## Product Change Notice – E4 Change

ARCOL UK Limited are notifying their customers that a dimensional difference is being made to the ARCOL products being manufactured using E4 pins – These being the HS75 E4, HS100 E4 and HS150 E4 product families.

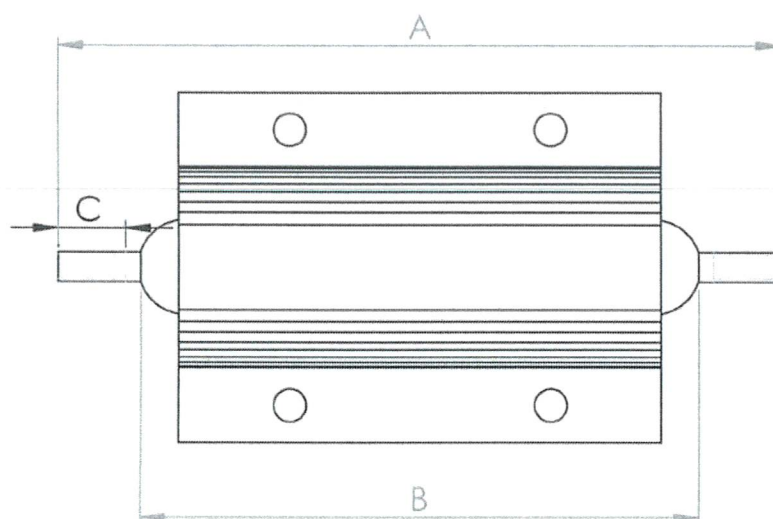
The changes are being made to bring the E4 dimension A in line with the E6 product family. This also impacts Dimension C. – See table below for details.

Product	DIM A MAX	DIM B MAX	DIM C +/-0.20
HS75 E4 prior to change	82.50	61.0	10.00
HS100 E4 prior to change	99.20	77.5	10.00
HS150 E4 prior to change	132.00	110.0	10.00
HS75 E4 post change	92.50	61.0	14.00
HS100 E4 post change	109.20	77.5	14.00
HS150 E4 post change	142.00	110.0	14.00
